<b>DOCKETED</b>	
<b>Docket Number:</b>	23-OPT-01
<b>Project Title:</b>	Fountain Wind Project
<b>TN #:</b>	248330-4
<b>Document Title:</b>	Project Revisions Memo Feb 2021
<b>Description:</b>	N/A
<b>Filer:</b>	Caitlin Barns
<b>Organization:</b>	Stantec Consulting Services, Inc.
<b>Submitter Role:</b>	Applicant Consultant
<b>Submission Date:</b>	1/5/2023 10:09:40 AM
<b>Docketed Date:</b>	1/5/2023

To:	Lio Salazar	From:	Caitlin Barns
	Shasta County Planning		Portland, Oregon
File:	Fountain Wind Project	Date:	February 12, 2021

**Reference: Analyses of Refinements to the Project Description Since Circulation of the Draft Environmental Impact Report**

Figure No.  
1

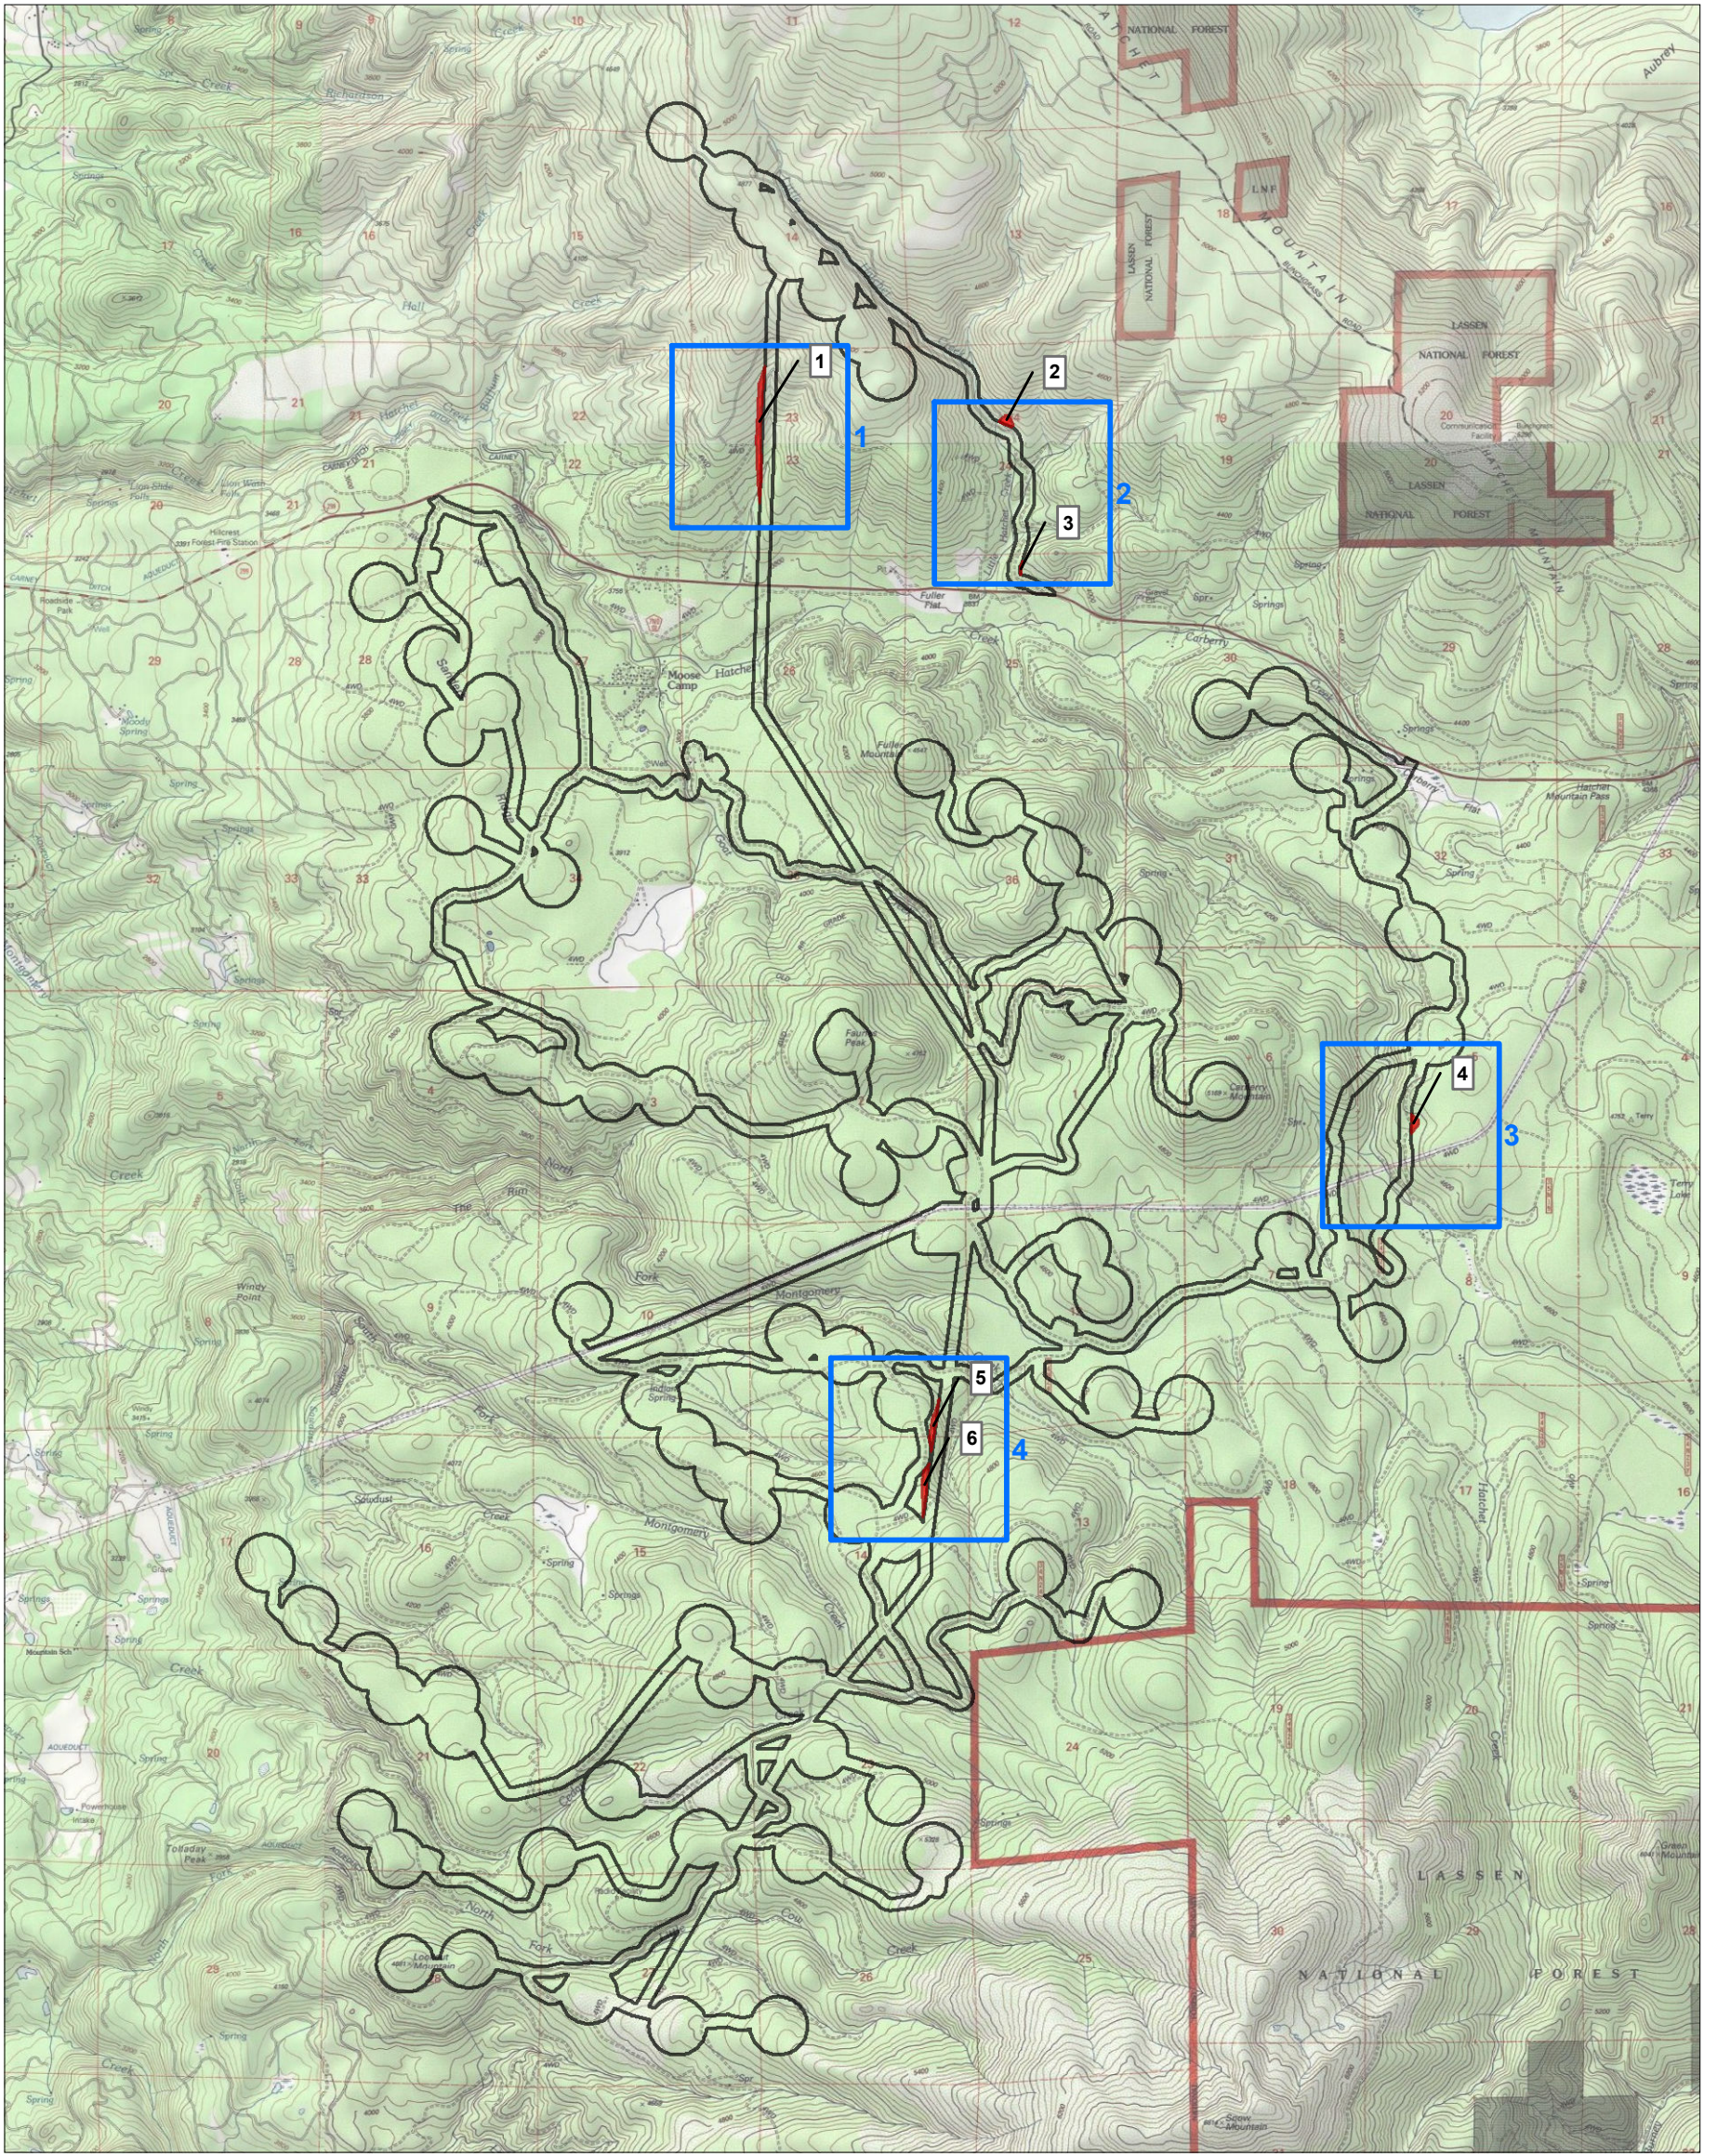
- **Layout refinements to avoid sensitive environmental resources and improve engineering design.** Since the circulation of the DEIR, the applicant has refined the project footprint by eliminating one wind turbine generator location, and realigning access roads and electric collection lines. This has resulted in the avoidance or minimization of impacts on sensitive environmental resources, including a reduction in direct impacts on aquatic resources, riparian habitats, and a previously identified cultural site (FW 11). The majority of these changes occur within the Project Site defined in the DEIR, but several adjustments occur slightly (<500 ft) outside the Project Site boundaries, resulting in the need for additional surveys. A comparison of the modified project footprint in relation to the Project Site examined in the DEIR is depicted in Figure 1.

- Refinement 1 (Survey Area 1): moved overhead collection line and associated access road up to approximately 250 ft west to avoid existing drainage and associated aquatic features including a perennial stream, intermittent stream, and riparian wetland segments.

- Refinement 2 (Survey Area 2): moved access road up to approximately 130 ft northeast in order to utilize existing crossing of a nearby perennial stream and associated adjacent wetlands.

- Refinements 3 (Survey Area 3): moved access road up to approximately 125 ft east in order to straighten access road.
  - Refinement 4 (Survey Area 4): moved access road up to approximately 275 ft east in order to utilize existing access road.

- Refinement 5 and 6 (Survey Area 5 and 6): moved overhead collection line up to approximately 250 ft west in order to avoid building collection line on sloping terrain and align with an existing access road corridor.

- Refinement 7 (FW 11): moved underground collection line approximately 100 ft west to avoid cultural resource site.
